**RE: Notice of Exhibition – Modification Request 1 Catherine Field Primary School (SSD 9477)**

**PROPERTY: O'Keefe Drive ORAN PARK  
LOT: 1001 DP: 1234527**

Figure 1: Mod 1 plans showing location of retaining wall.

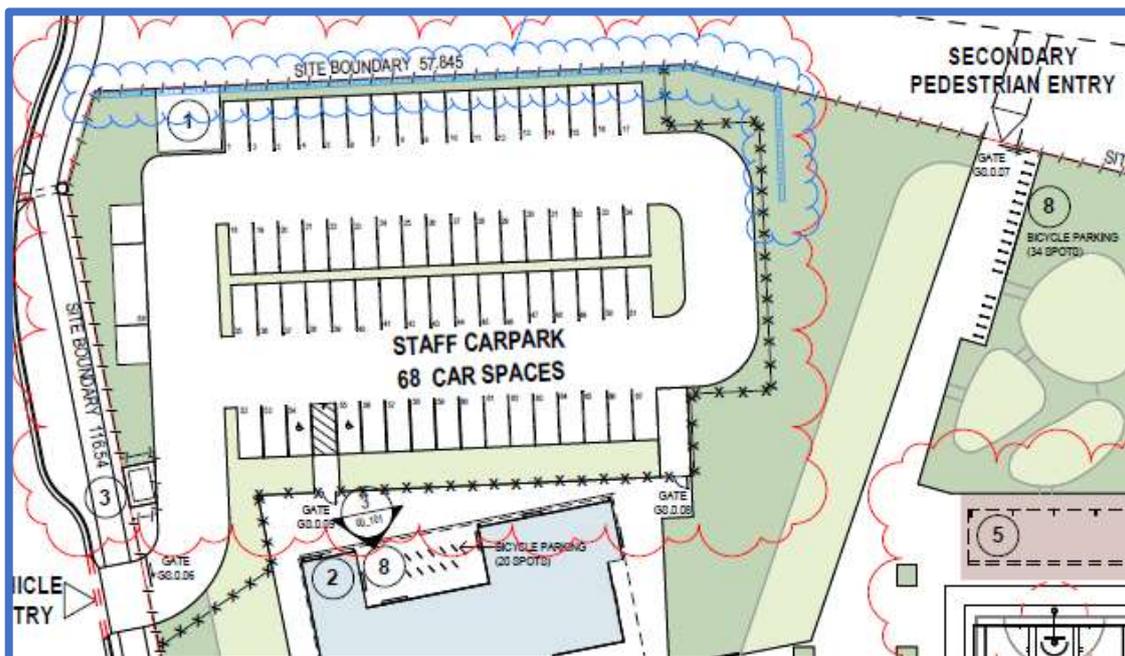
As indicated by the plans for Mod 2, the applicant’s intention is to provide an access point from the adjoining sporting field access (known as LS1) into the school car park. It appears the retaining wall will be around 1.4m tall in the area of the access way and future footpath (no chainages provided in the Engineering plan to confirm the exact wall height around the future area).

The location of retaining wall should be revised to be entirely consistent with the location of the retaining wall proposed in Mod 2 which allows for vehicular and pedestrian access to and from LS1.
